# Access Compliance Report

## Public Rights-of-Way

### (Curb Ramps)

Intersection ID: 53886	Main Street: PAW_VALLEY_LN	Cross Street: N/A	Location: SW
ADA ID: 4FF3F8BE646E	Ramp Type: PerpDiag	Initial Pass/Fail: Fail	Overall Compliance: No
Codes/Mitigation Info/Possible Solution		Field Measurements/Component Compliance	
Severity Score: 8.75

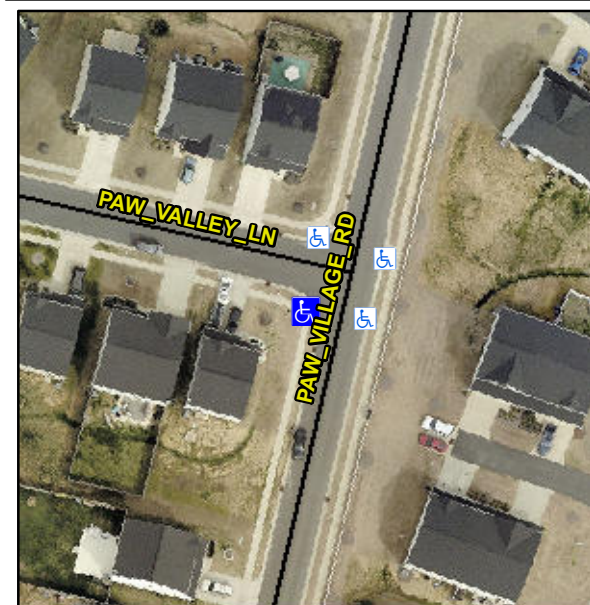
**Not Found, R304.5.1**

Compliance	Description	Data	Compliance	Description	Data
N/A	Ramp Length (in)	50.0	Yes	Ramp Slope (%)	5.6
No	Ramp Width (in)	47.0	Yes	Ramp XSlope (%)	1.4
N/A	Flare Type LT	N/A	N/A	Flare Type RT	N/A
N/A	Flare Slope LT (%)	N/A	N/A	Flare Slope RT (%)	N/A
N/A	Flare Traversable LT?	N/A	N/A	Flare Traversable RT?	N/A
N/A	Landing Length (in)	N/A	N/A	DWS Provided?	N/A
N/A	Landing Width (in)	N/A	N/A	DWS Contrast?	N/A
N/A	Landing Slope (%)	N/A	N/A	DWS Length (in)	N/A
N/A	Landing X Slope (%)	N/A	N/A	DWS Full Width?	N/A
N/A	Landing Curb? (Y/N)	N/A	N/A	DWS Offset (in)	N/A
N/A	Shared Landing?	N/A			
N/A	Gutter Ponding?	N/A	N/A	Gutter Slope (%)	N/A
N/A	Gutter Lip Ht (in)	N/A	N/A	Gutter X Slope (%)	N/A
N/A	Painted X Walk1?	No	N/A	Painted X Walk2?	No
	X Walk 1 Direction	To E		X Walk 2 Direction	To N
N/A	X Walk 1 Width (in)	N/A	N/A	X Walk 2 Width (in)	N/A
	X Walk 1 Slope (%)	5.4		X Walk 2 Slope (%)	3.6
	X Walk 1 X Slope (%)	3.4		X Walk 2 X Slope (%)	5.6

N/A	Ramp inside XWalk1?	N/A	N/A	Ramp inside XWalk2?	N/A
	Road Slope (%)	1.1	N/A	Clear Space?	N/A
	Road X Slope (%)	6.6	N/A	Clear Space to XWalk (in)	N/A
N/A	Any Obstructions?	N/A	N/A	Storm Grate/Utility Hazard?	N/A
	Obstruction Type			Storm Grate/Utility Type	
		N/A			N/A
			Yes	Surface Condition? (G/P)	Good

**Remove & Replace Curb Ramp With Two New Directional Ramps or Equivalent.**
